Friends of the North Coast
Rural Bonny Doon Association

April 18, 2024

Re: Comment Letter re Project for Northern Parking Area and Trailhead and Draft Environmental Assessment (DOI-BLM-CA-C090-2023-0001-EA) at Cotoni-Coast Dairies, a Unit of the California Coastal National Monument

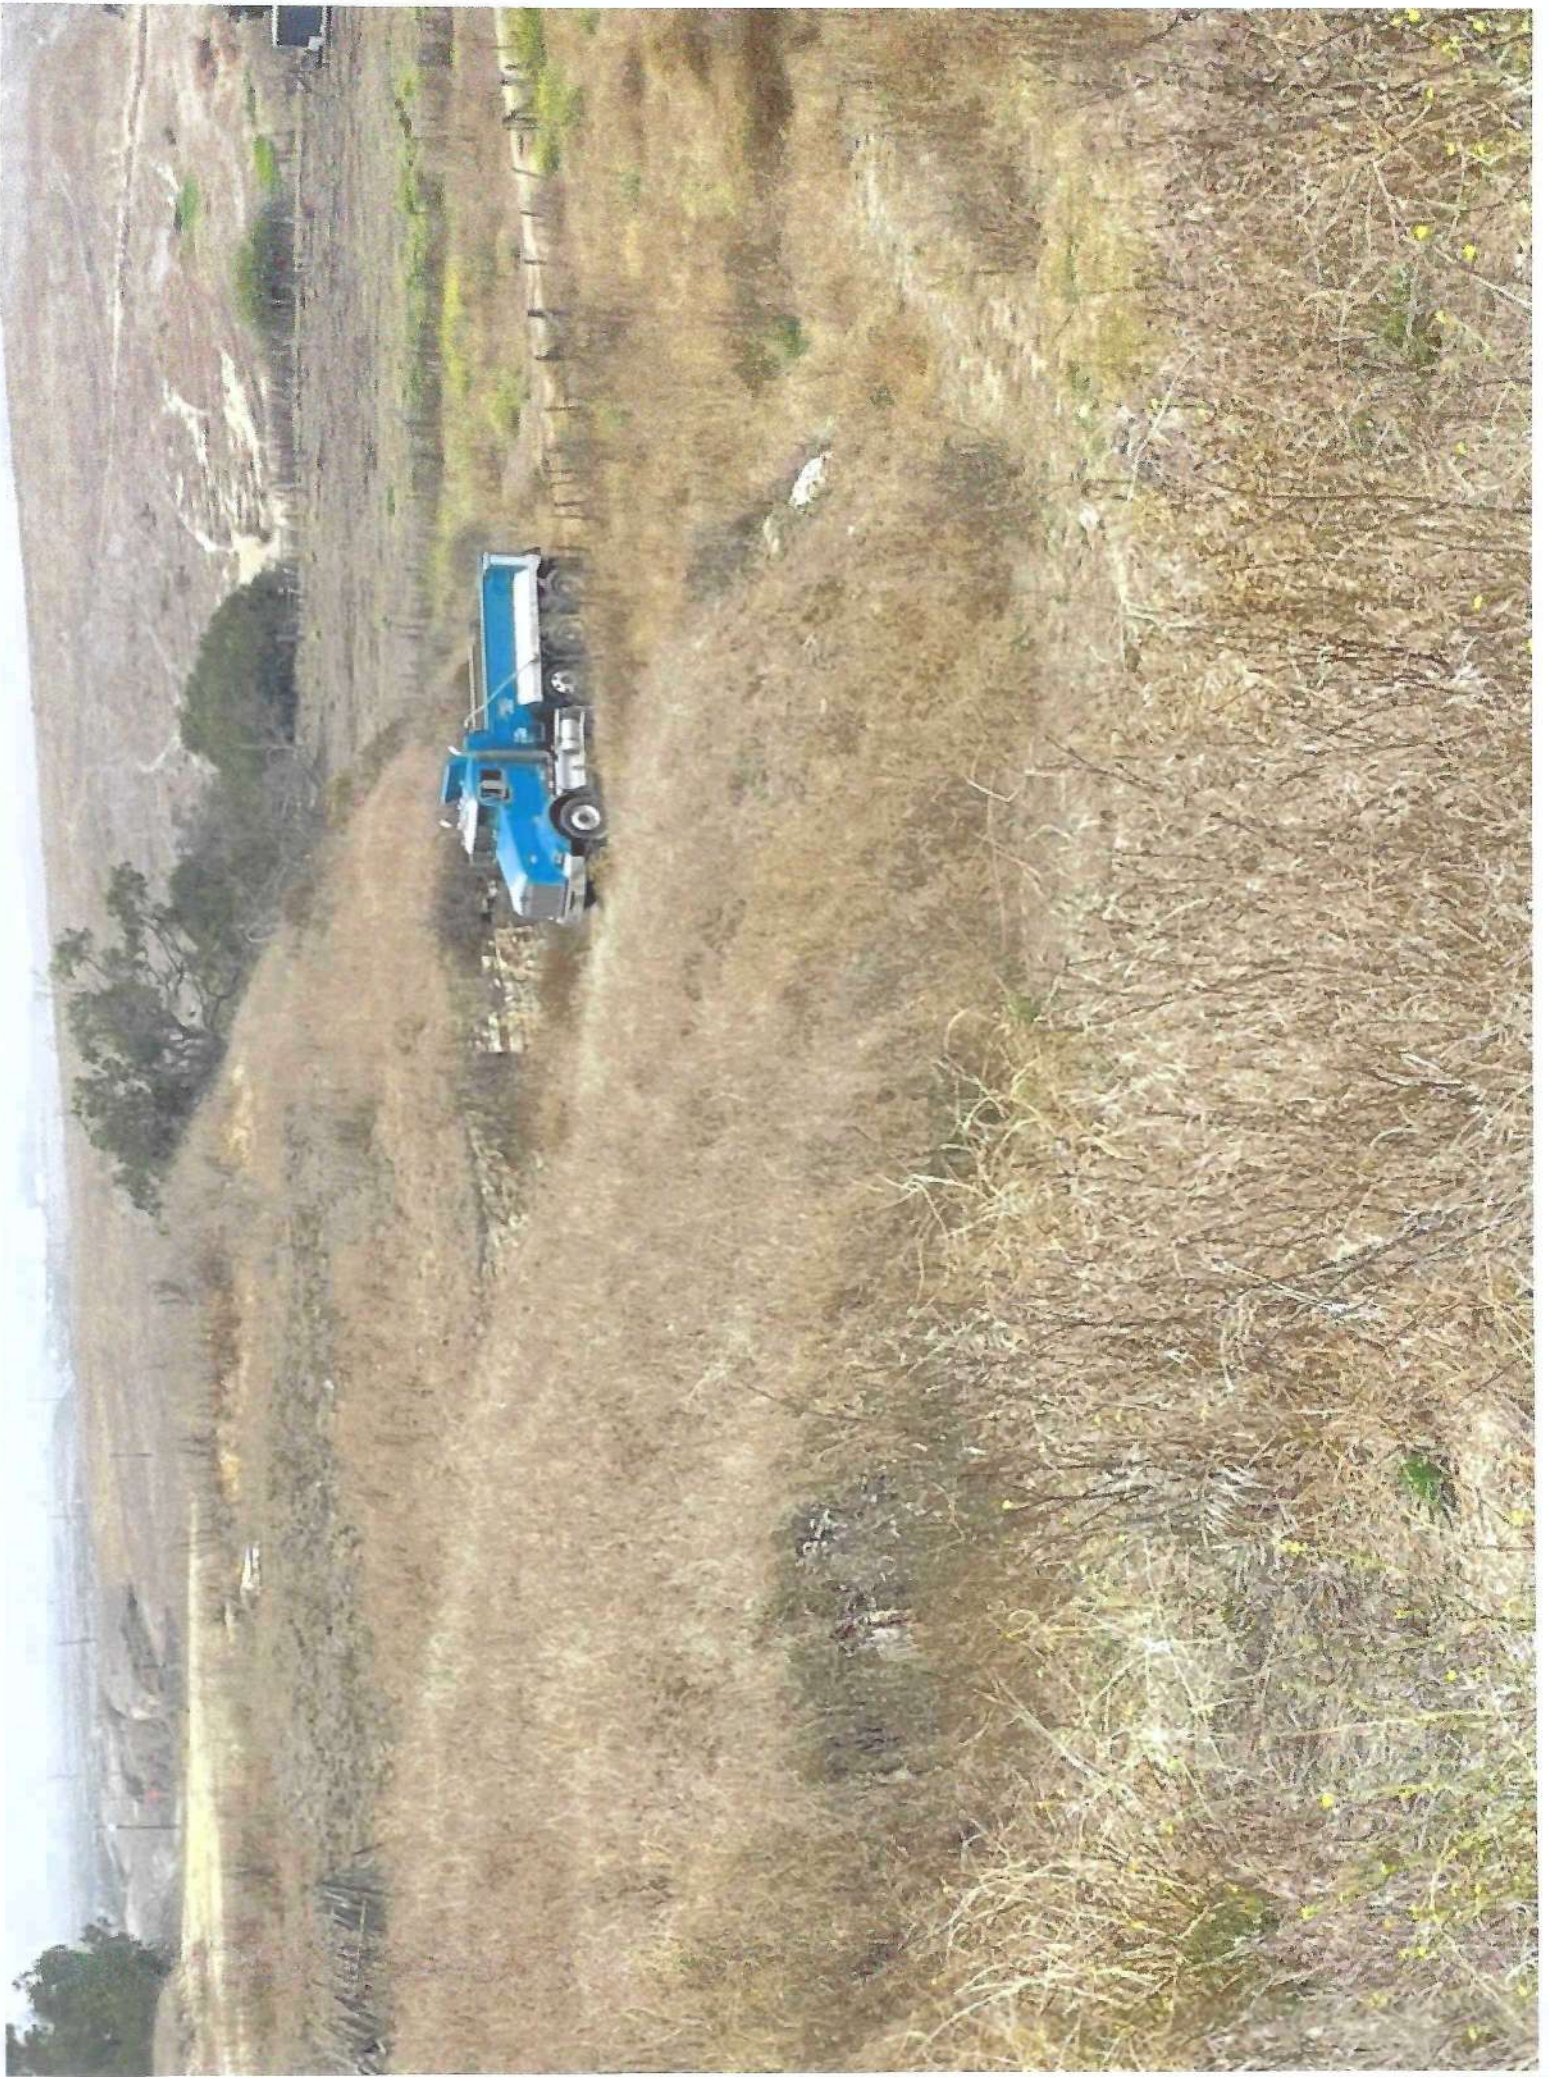
None of the Alternatives for creating a Northern Entrance Parking Area protect the Monarch Overwintering Habitat along Cement Plant Road north of Warrenella Road. Commenting Parties submitted a "Preferred Northern Entrance Package" along with their Scoping Comments for this process and that Alternative protects the Monarch Overwintering Habitat by an Access near the foot of the knoll proceeding around the inland side of the knoll and up the draw to BLM's knoll-top parking area.

A reasonable range of alternatives should include this route, without lower level parking at this time. Instead, the EA erroneously described the Community's Alternative as "emphasiz[ing] parking near the historic barn structure" (EA p.20-21). The EA created used some alternative plan instead of using the professionally prepared Landscape Architect Plan and Notes (inserted after this page) submitted by DNCA, FONC, and RBDA which show the roadway and parking adjacent to the base of the knoll as far away from the historic barn structure and corrals as possible. From that Plan and Notes it can easily be seen that a 24-foot wide stand-alone road can be constructed on the elevated area and avoid the areas of runoff inundation and be connected directly to the haul route for the dump trucks going up the draw to the knoll top.

3-18-2022

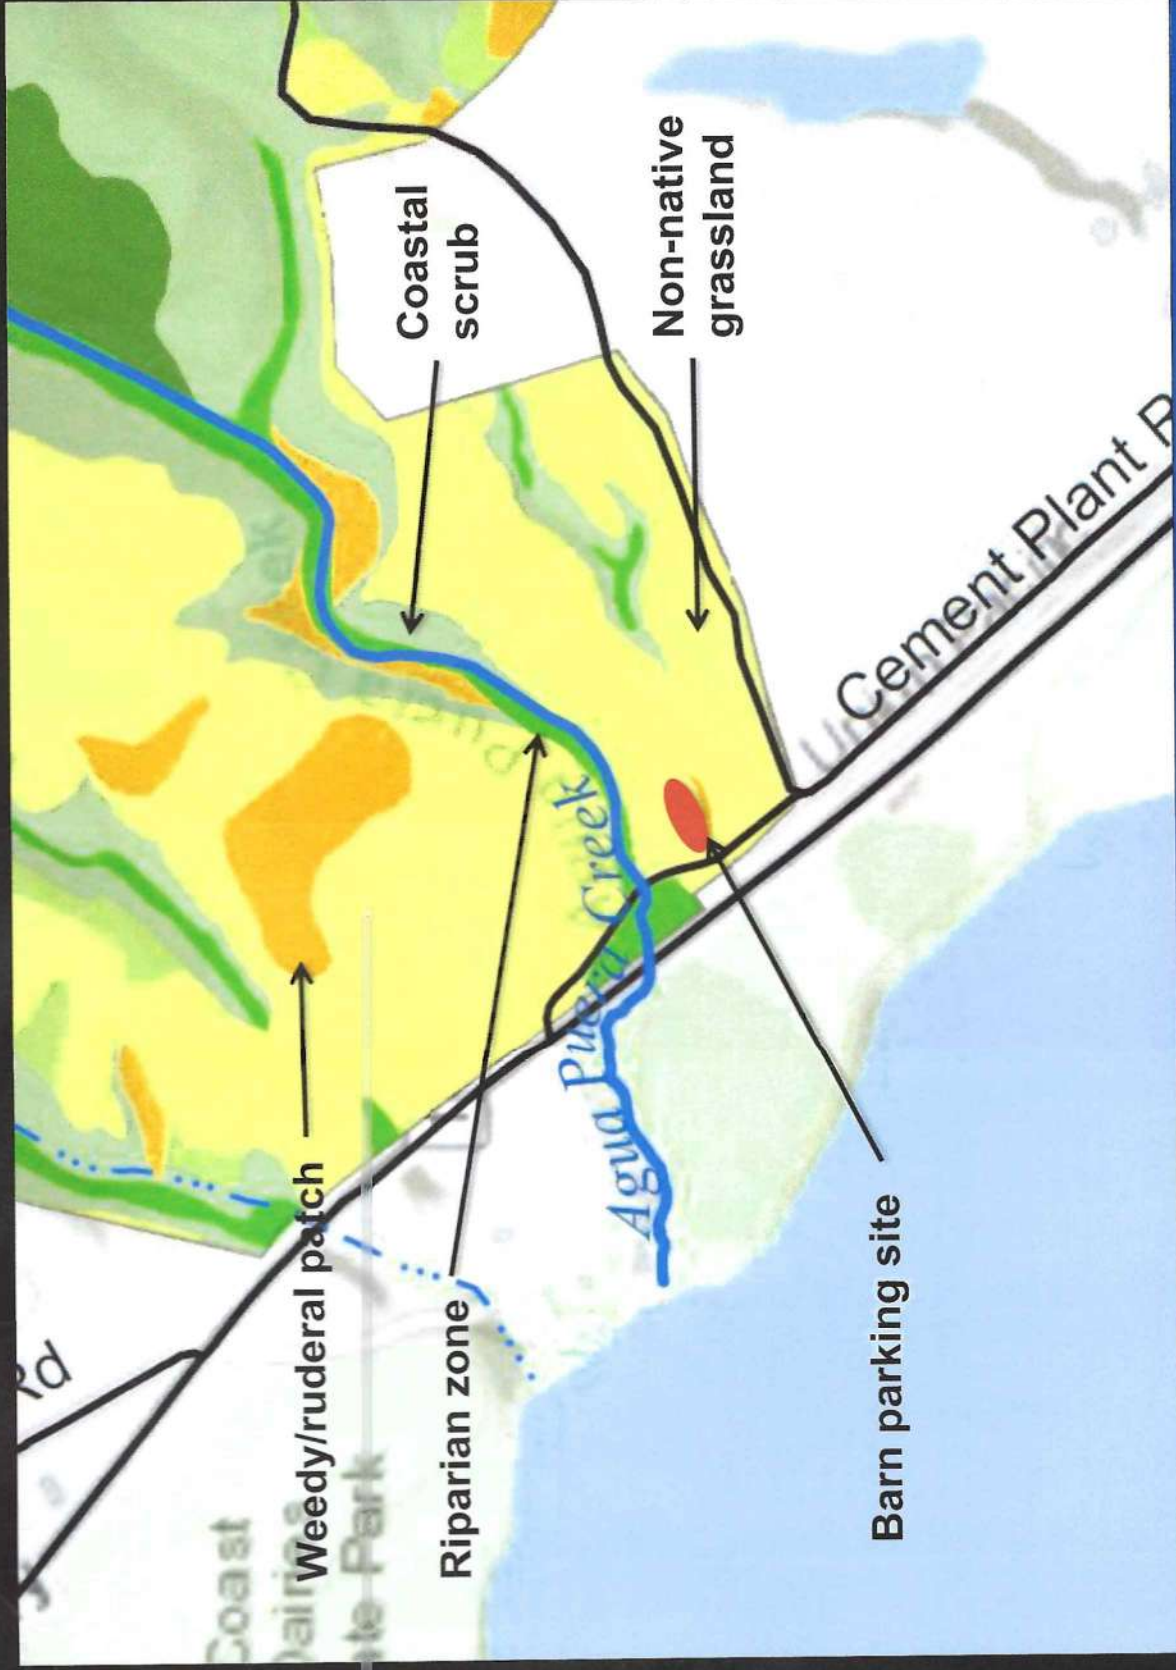
A few things to note about this layout:

1. The parking and access road are laid out to avoid the steep slope of the mesa to the south.
2. There's a power pole on Cement Plant Road right at the entrance location which I show (approximate) in the lower left corner. Your [John Barnes] parking layout does not show the pole and it didn't appear there was enough room to put the parking entrance road on the south side of the pole.
3. The drawing shows the existing ranch fence in light blue and a proposed fence in yellow. The area of the parking impact into the coral would be about 0.29 acres.
4. There are roughly 55 parking spaces and 2 ADA spaces. You could probably squeeze in 10 more spaces or provide parallel parking in a few locations.
5. The road is 24' wide, the parking spaces 9'x18' and the turnaround has 37' Rad.

3c.i RMPA Vegetation / Riparian Zone Map: Agua Puerca Creek

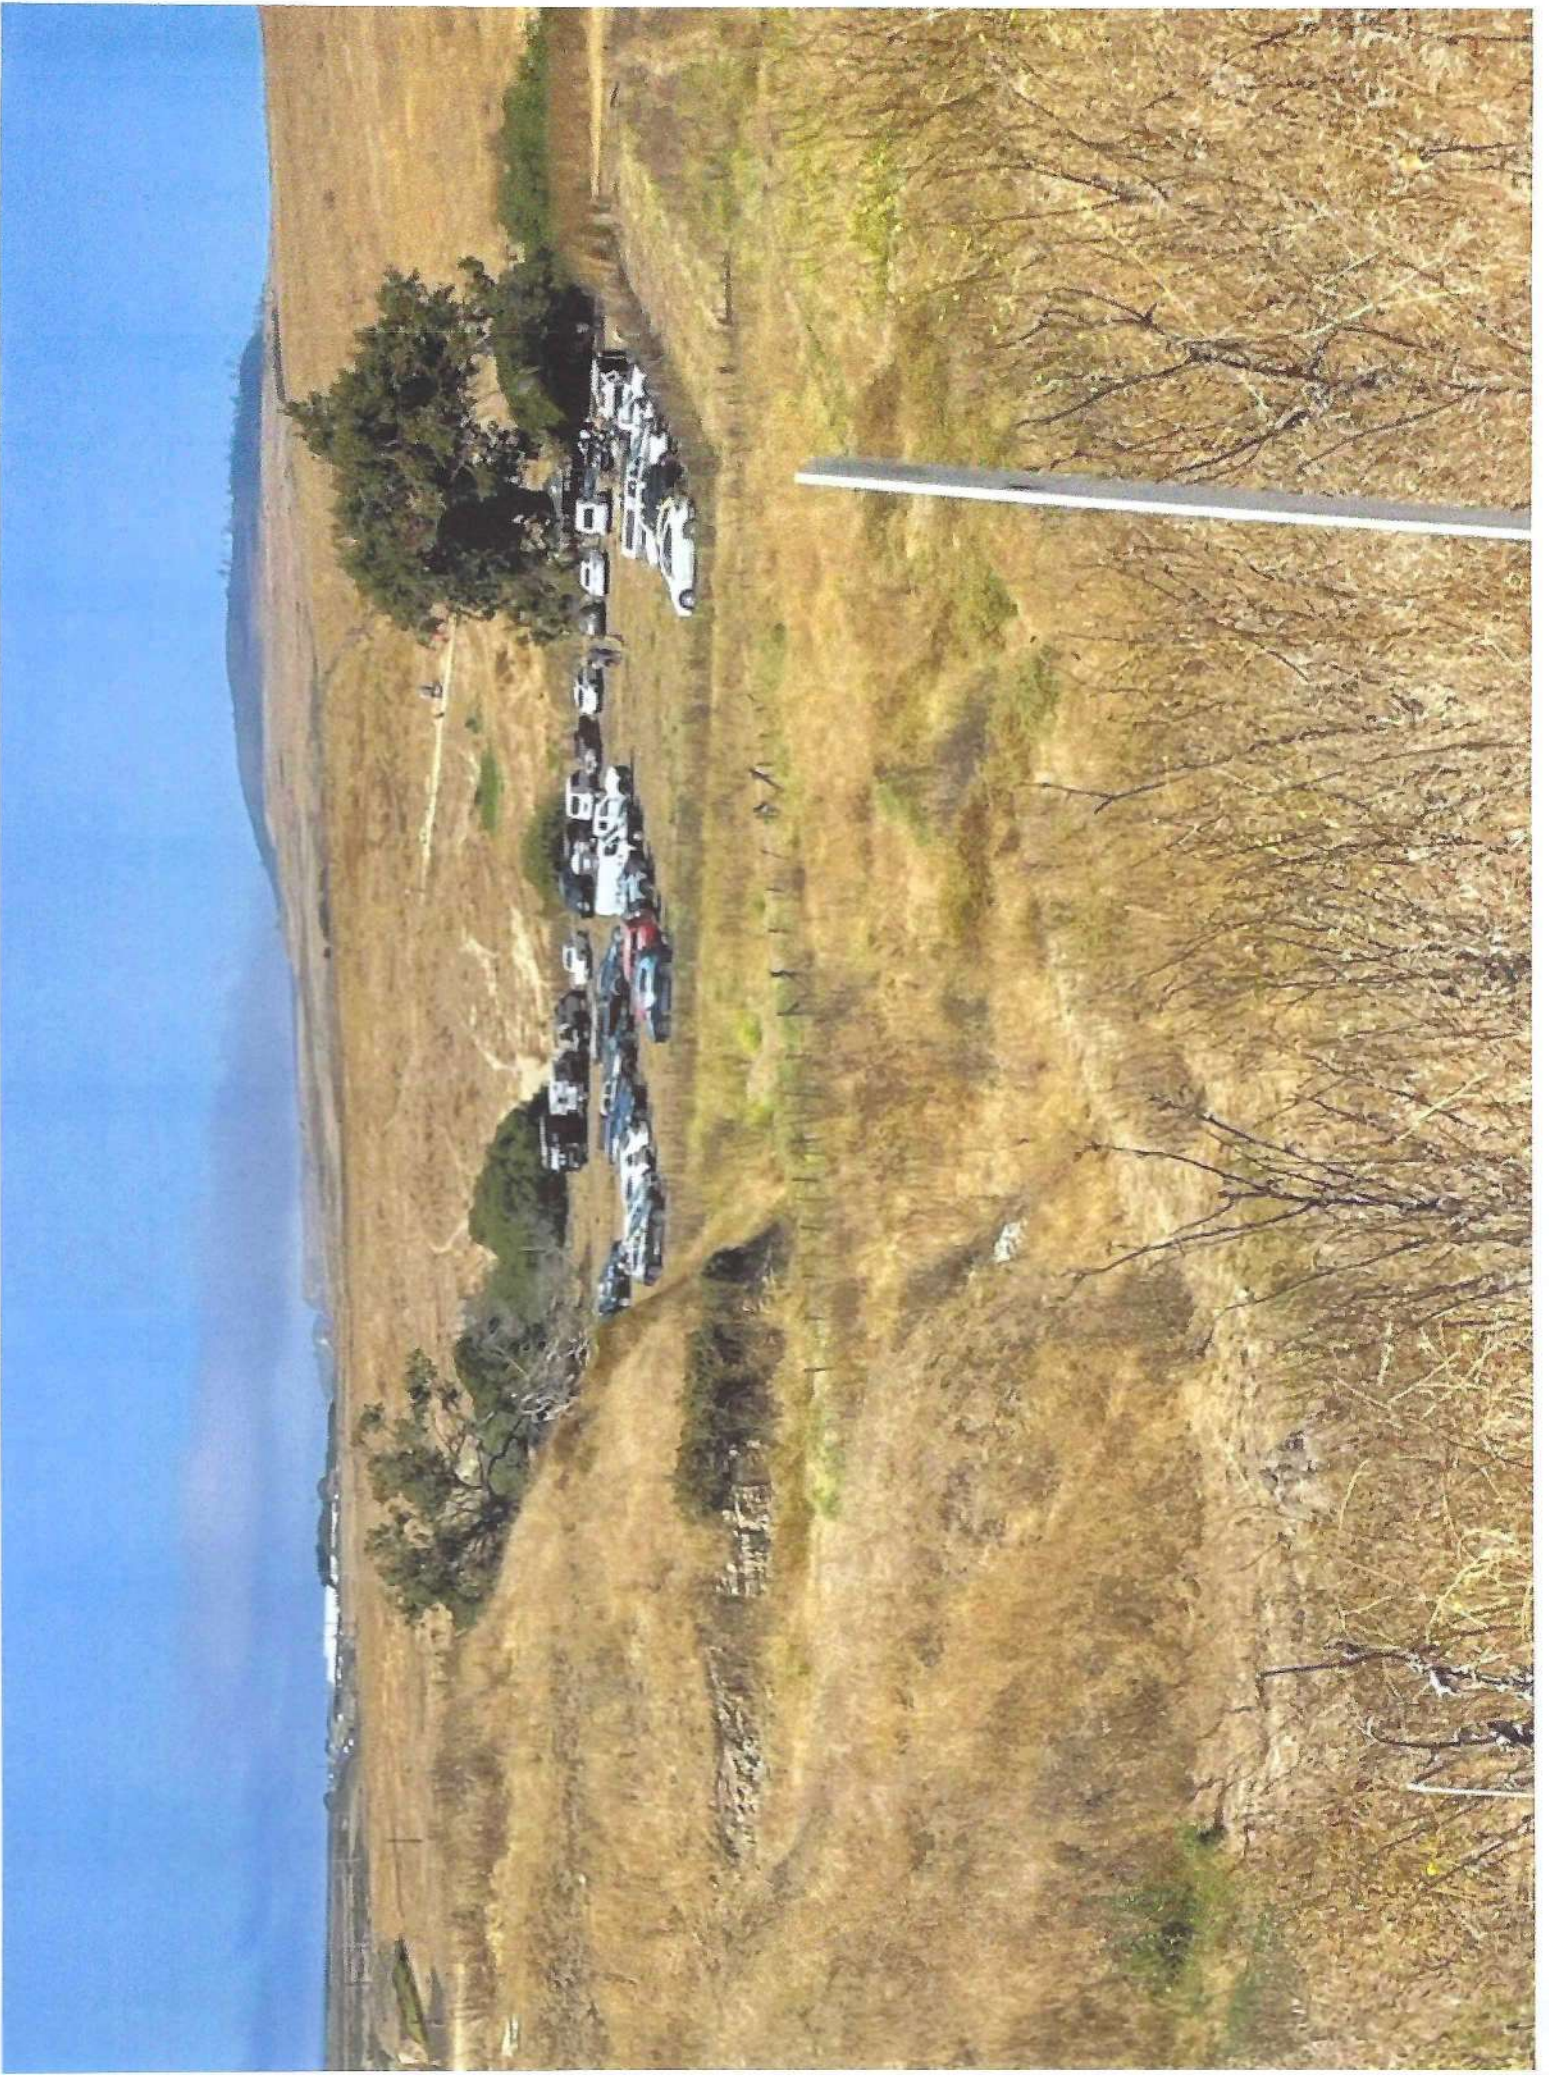
Furthermore, the riparian habitat associated with Agua Puerca Creek would not be adversely affected because BLM's Resource Management Plan includes a Vegetation/Riparian Map (RMPA Appendix Figure 3 – Vegetation - attached) which demonstrates that the Riparian Area Habitat is no more than 50-75 feet from the southern edge of the Creek, whereupon it terminates at Mocettini Barn and the actively used livestock corrals. From there to the inland edge of the knoll is approximately 320 feet, all of which is designated non-native grassland.

Under Santa Cruz County Code 16.30.030, in this situation, “Riparian corridor” includes only the following: “...lands within a stream channel and extending 50 feet out from each side of a perennial stream, and lands containing a riparian woodland (composed of woody plant species that typically occur in wet areas along streams or marshes - characteristic species are: Black Cottonwood, Red Alder, White Alder, Sycamore, Box Elder, Creek Dogwood, Willow.” RMPA 2.6.1 states: “The BLM determined there is no specific management direction applicable to the C-CD for these [riparian and wetland] resources established in the CCNM RMP (BLM 2005) or IMP (BLM 2014). In lieu of specific goals and objectives, or management actions, the BLM would adhere to existing policy to meet State and Federal regulations to protect riparian areas and wetlands.

Figure 7. Grassland pasture and livestock corrals with precipitation induced flooding (BLM 2024).
2.5 inches of rainfall over 24-hours from January 21-22, 2024 - EA page 24

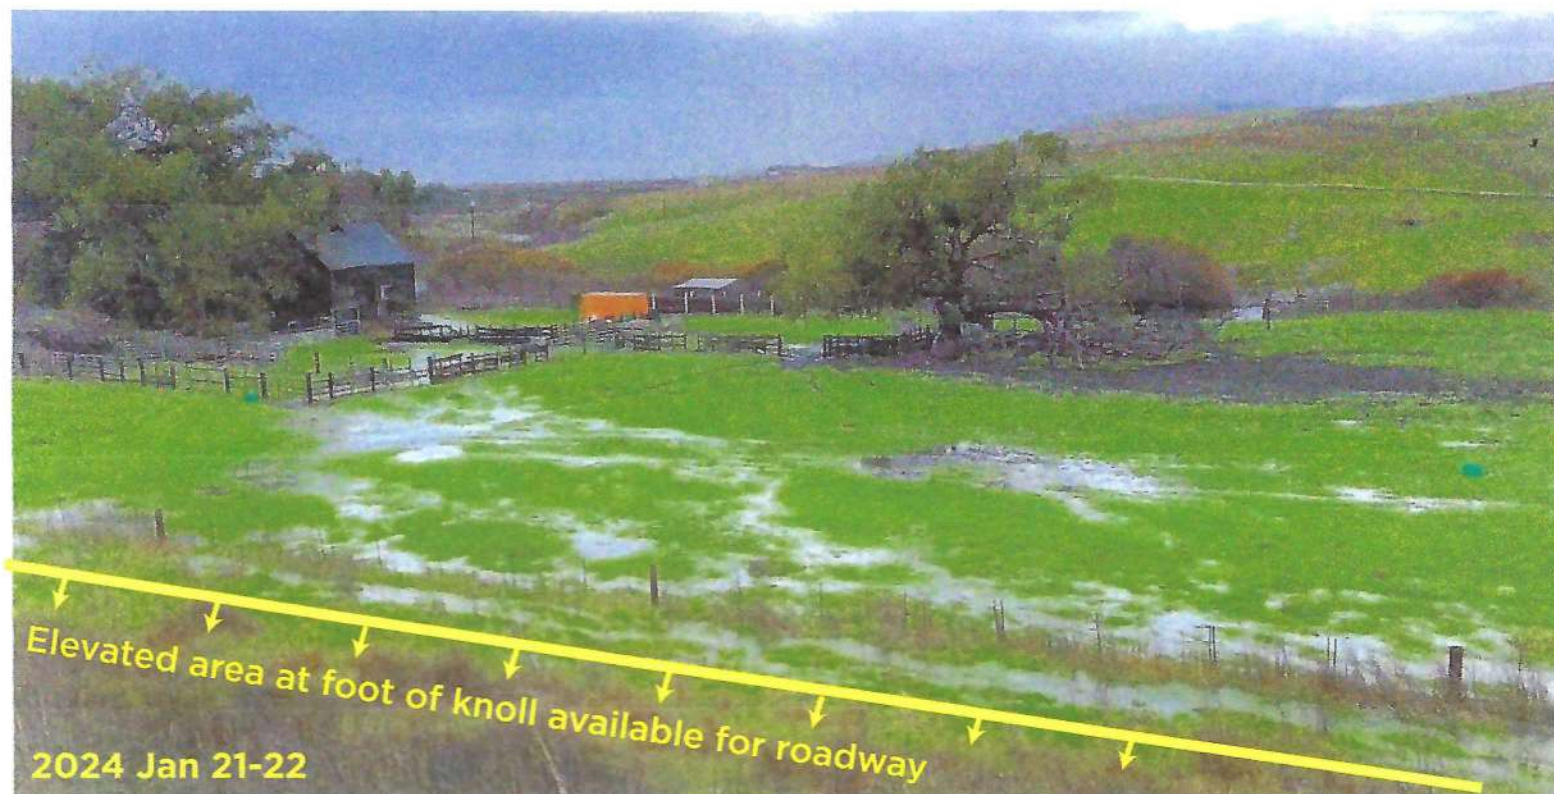
This seems to be a good point and would also apply to concerns about inundation on buffering for the Riparian Habitat at Agua Puerca Creek which is also seasonal. Please inform the public if it is correct that the cattle operation is in place only from November 1 – June 1. A photo of one of the "large scale event parking" occurrences near the end of October 2023 is attached after this page. Could this occur in the heavier visitation periods of late spring, summer, and early fall?

Yellow line delineates elevated area free from inundation
